## **Proposal for Supplement 6 to the 03 series of amendments to UN Regulation No. 51 (Noise of M and N categories of vehicles)**

### **Submitted by the Working Party on Noise and Tyres\***

## Supplement 6 to the 03 series of amendments to UN Regulation No. 51 (Noise of M and N categories of vehicles)

"Figure 3a

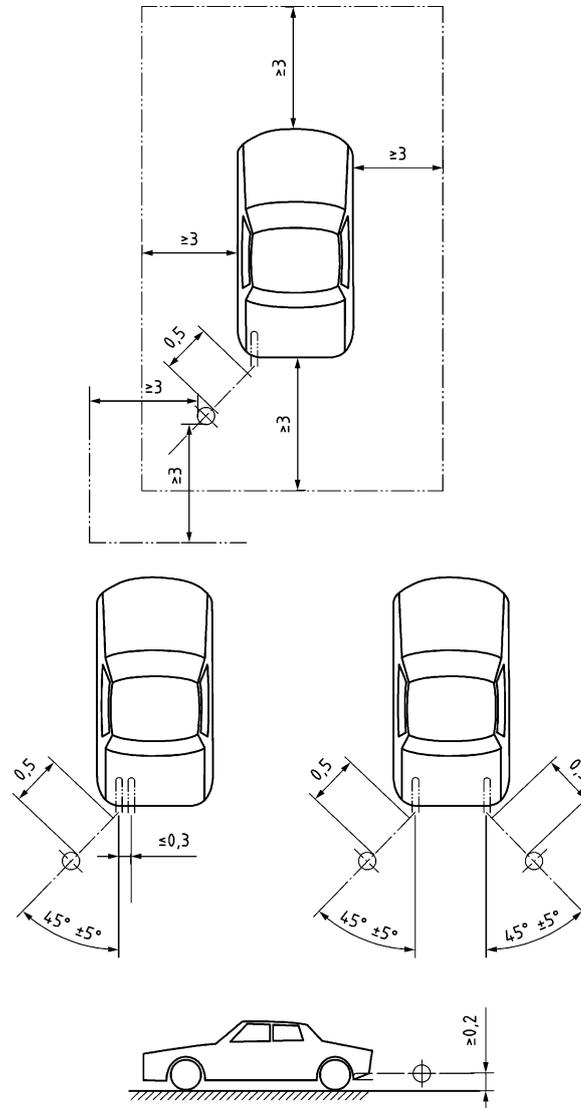
"3.2.5.3. Measuring of noise in proximity to the exhaust (see appendix of Annex 3, Figure 3a)."

Figure 3b

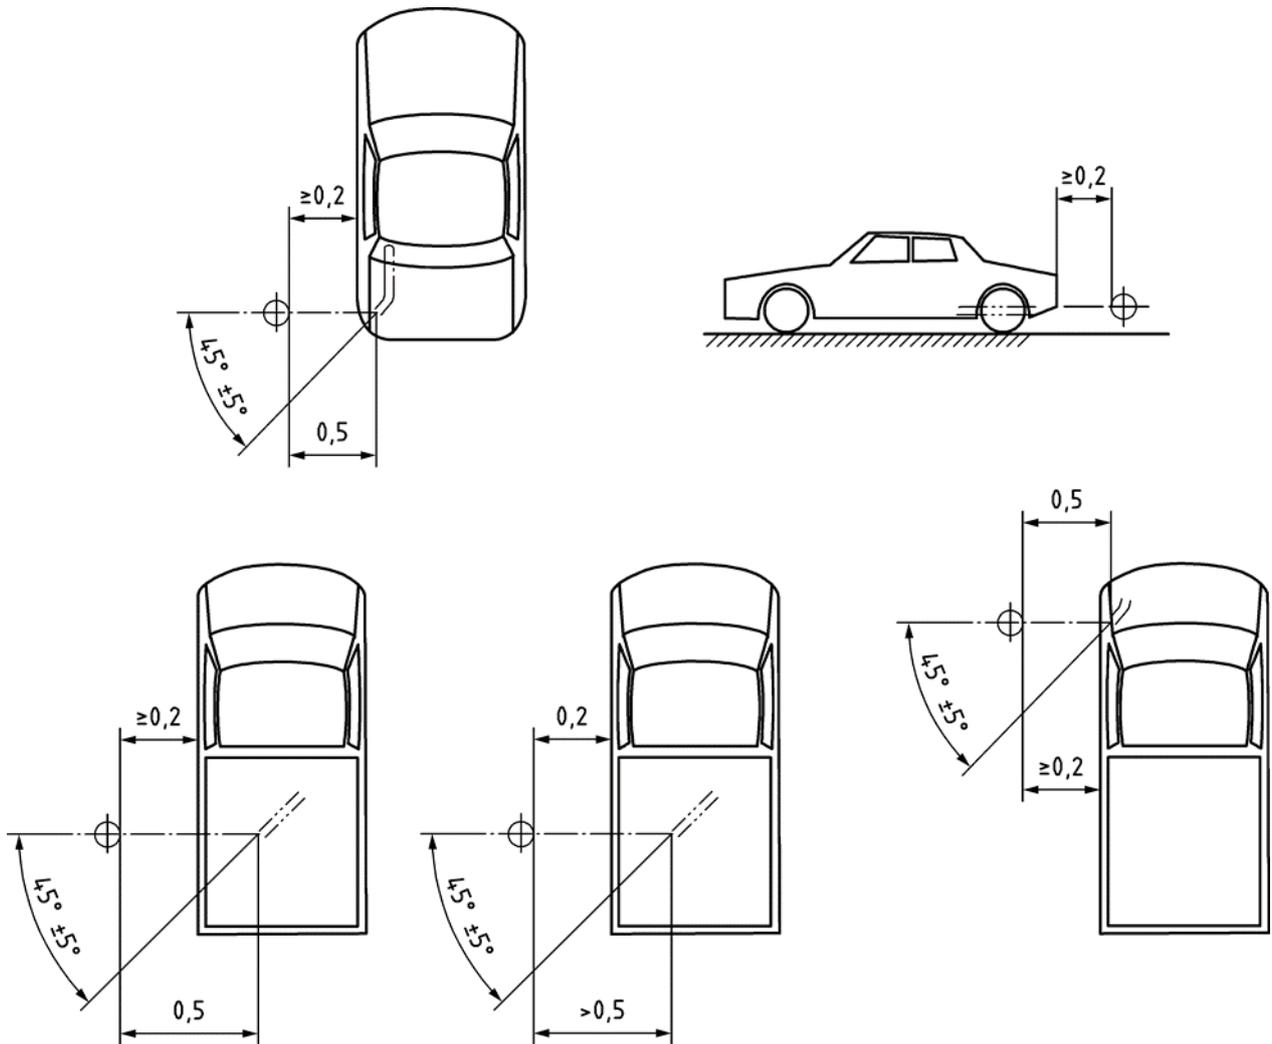
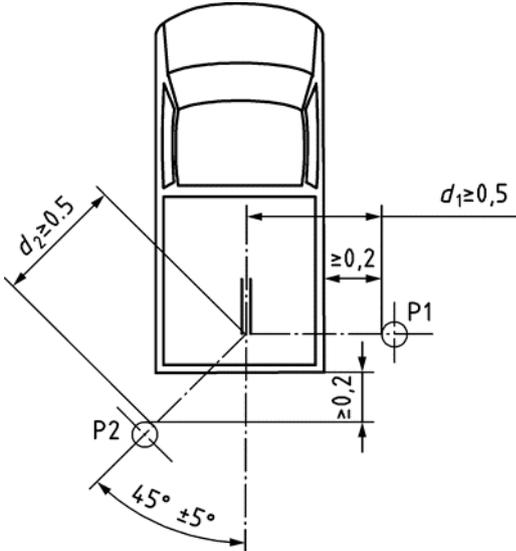
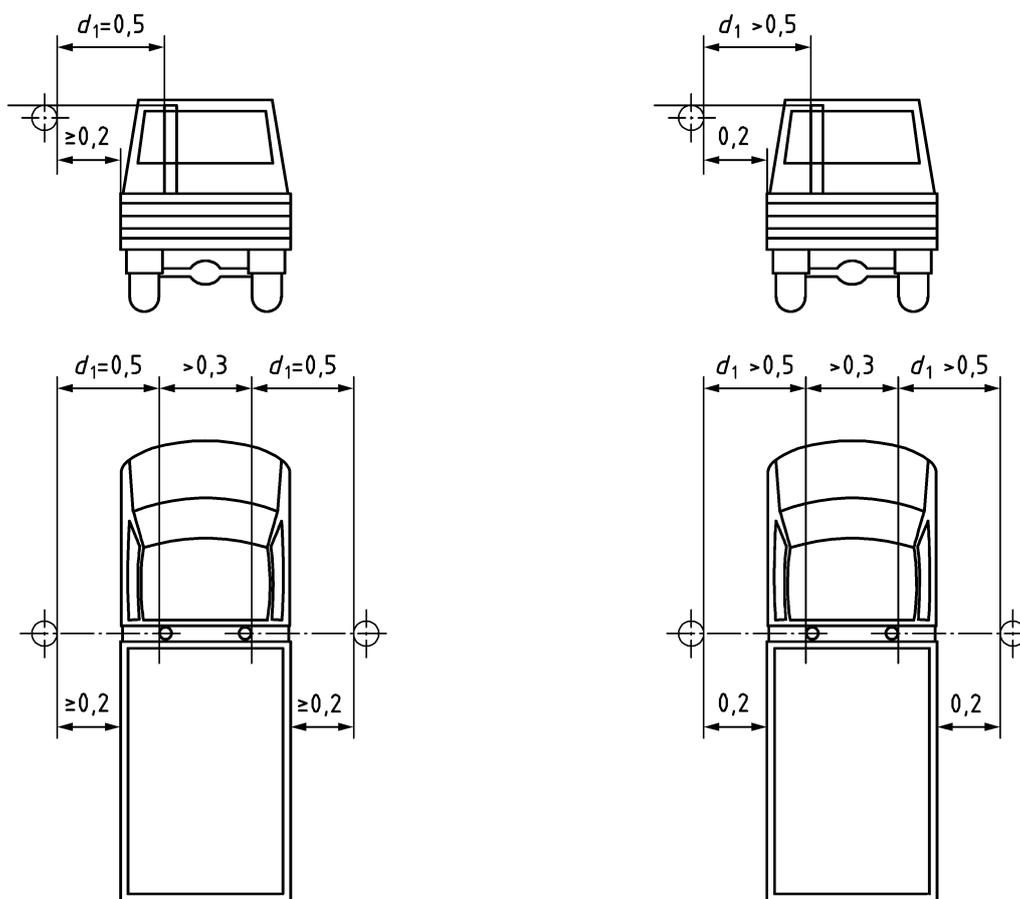
"3.2.5.3.1.5. For vehicles, where the reference point of the exhaust pipe is not accessible, or located under the vehicle body, as shown in Figure 3b and 3c in Annex 3, because of the

presence of obstacles which form part of the vehicle (e.g. spare wheel, fuel tank, battery compartment), the microphone shall be located at least 0.2 m from the nearest obstacle, including the vehicle body, and shall not be located under the vehicle. Its axis of maximum sensitivity shall face the exhaust outlet from the position least concealed by the above-mentioned obstacles. In case the distance from the exhaust outlet to the other side of the vehicle is larger than 0.2 m (Figures 3c and 3d in Annex 3), the following distances of  $d_1$  and  $d_2$  shall be chosen:

When several positions are possible, as shown in Figure 3c, the microphone position giving the lowest value of  $d_1$  or  $d_2$  shall be used."

**Figure 4a**

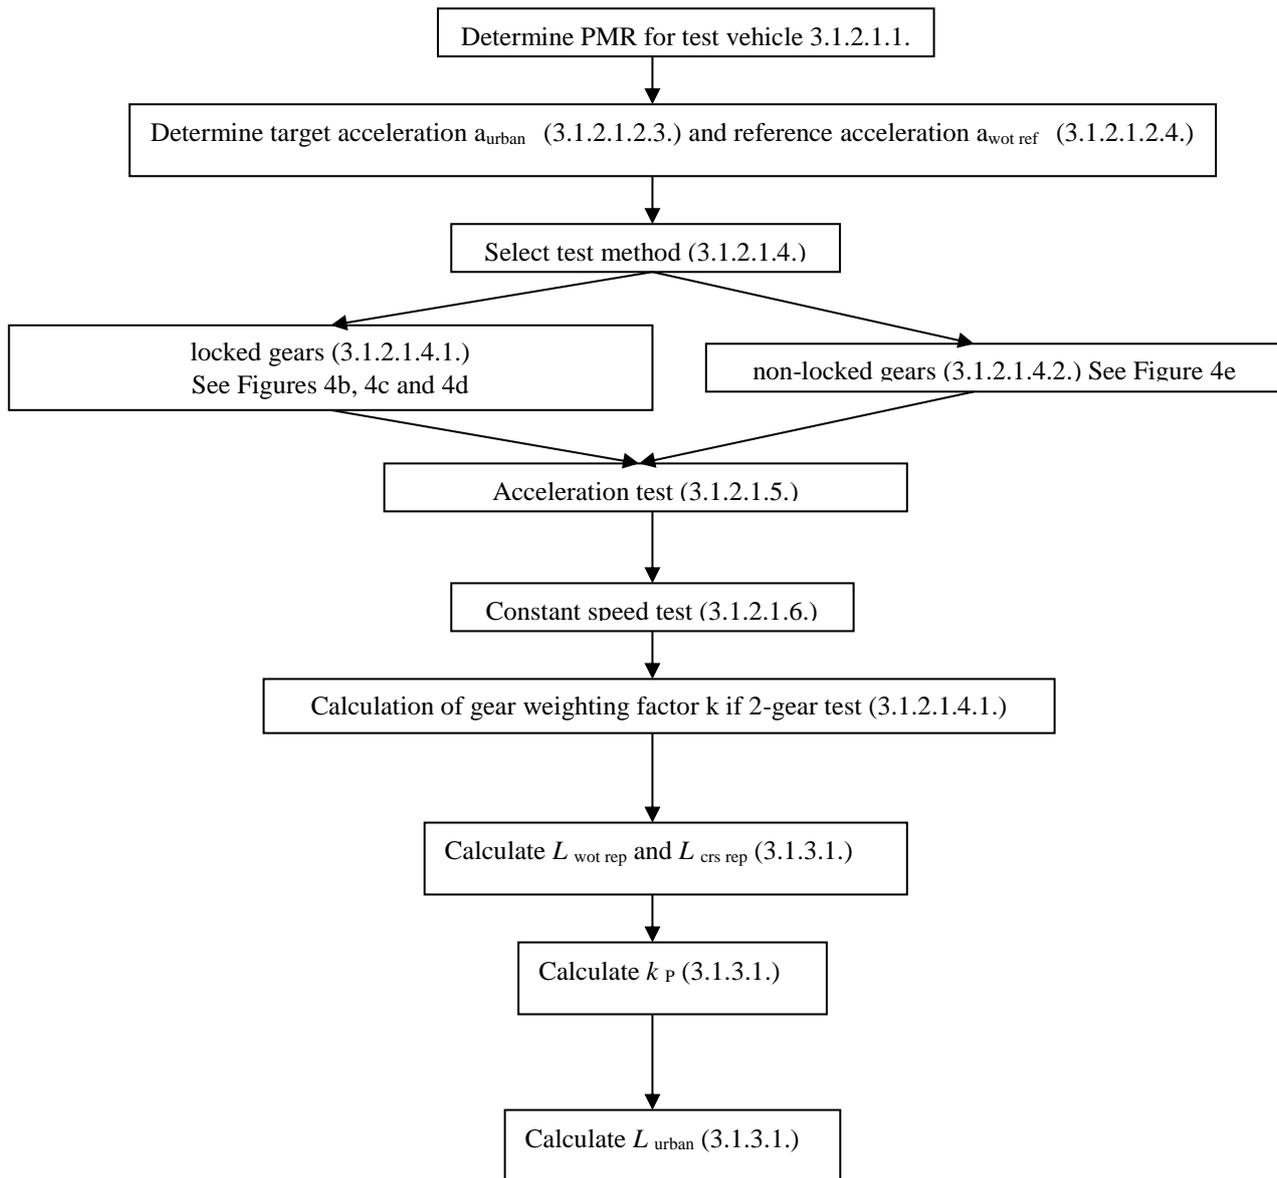
Figure 4a, amend to read:

Flowchart for vehicles tested according to paragraph 3.1.2.1. of Annex 3 to this Regulation  
 –  $L_{urban}$  computation

**Figure 4b**

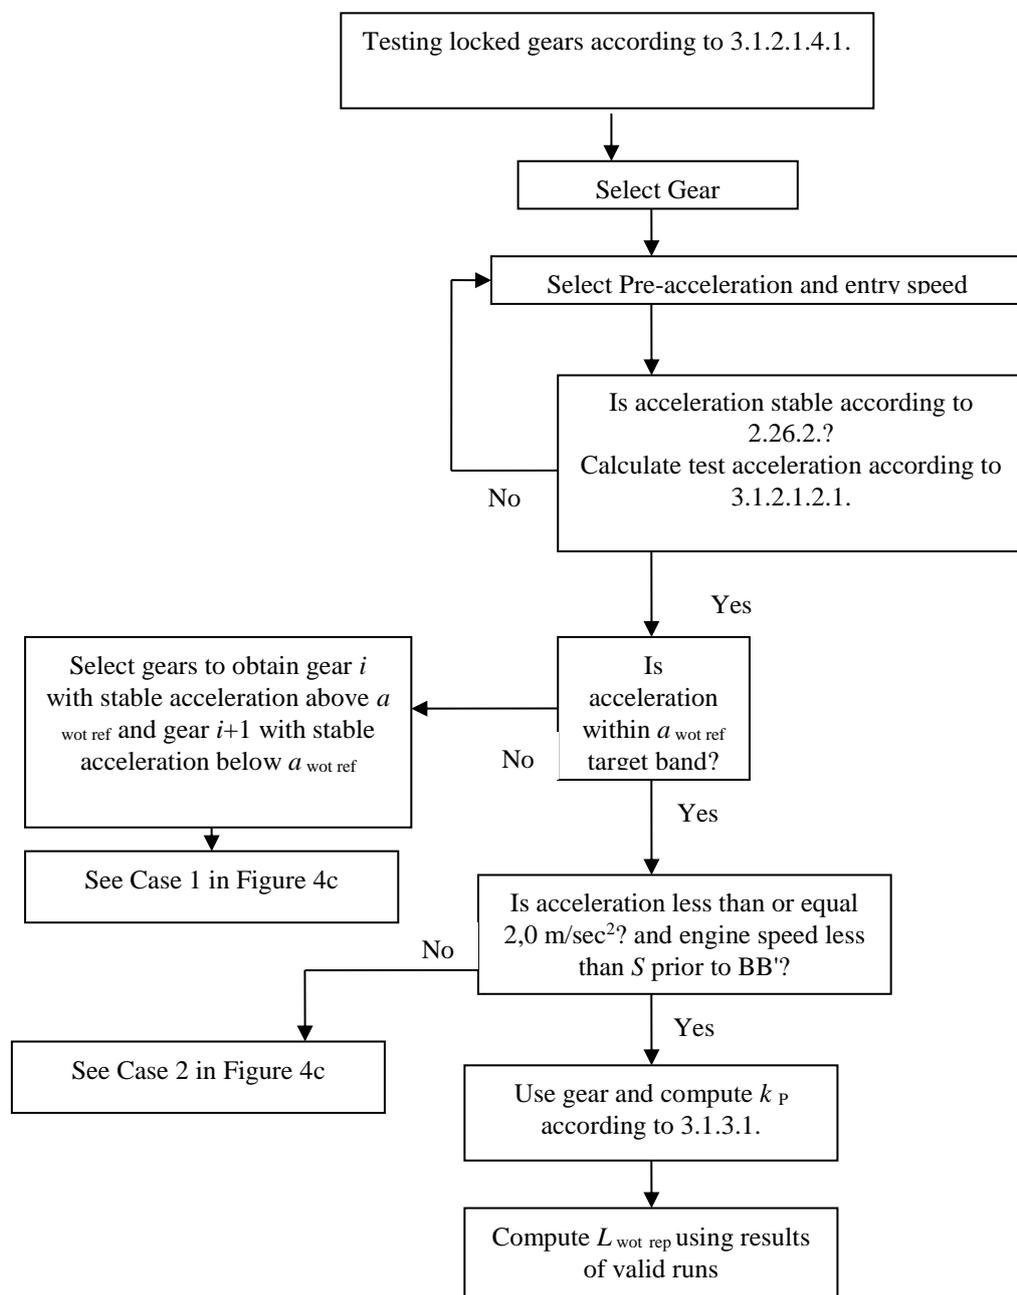
Figure 4b, amend to read:

Flowchart for vehicles tested according to paragraph 3.1.2.1. of Annex 3 to this Regulation  
- Gear selection using locked gear.

"Figure 6  
**Flowchart for measurement and data processing of stationary sound according to paragraph 3.2.**

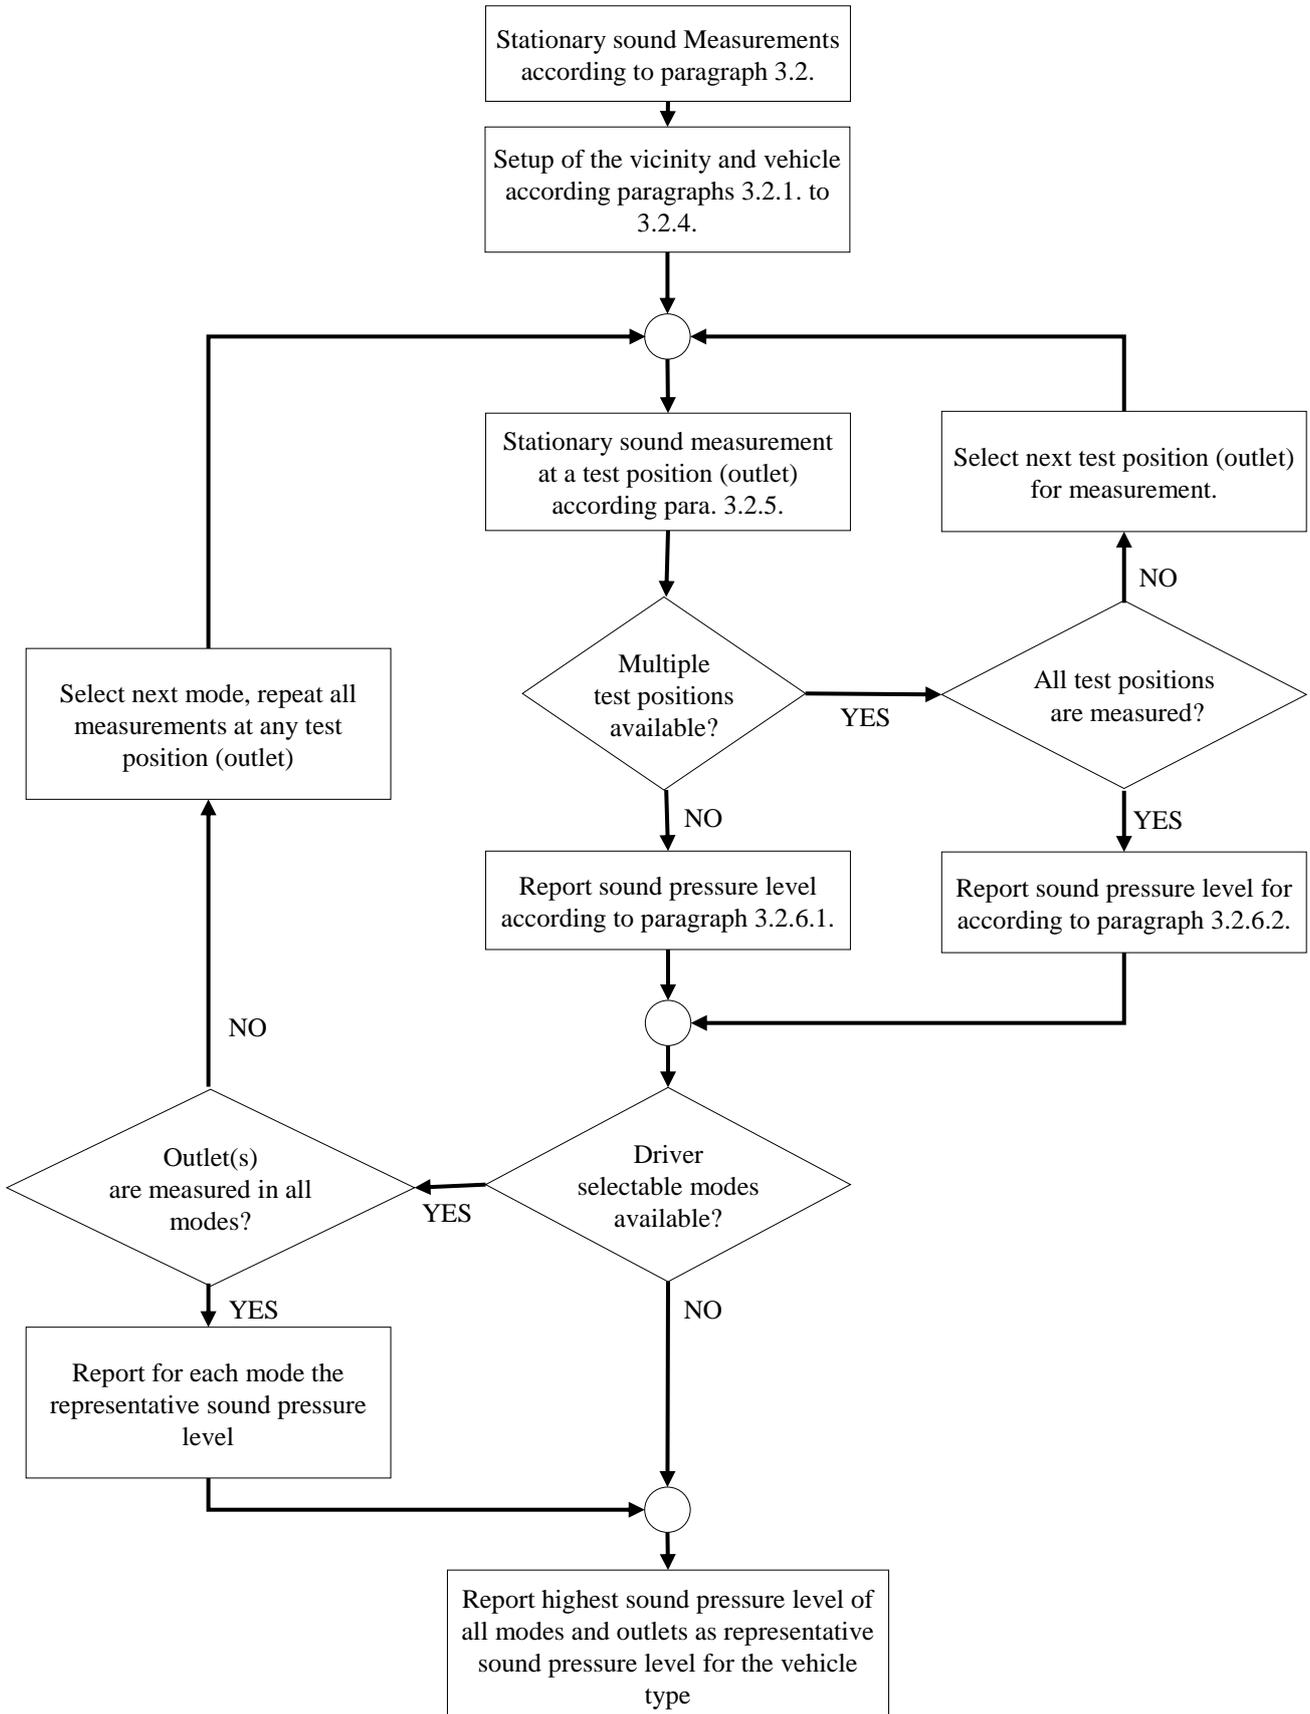
Add a new figure 6:
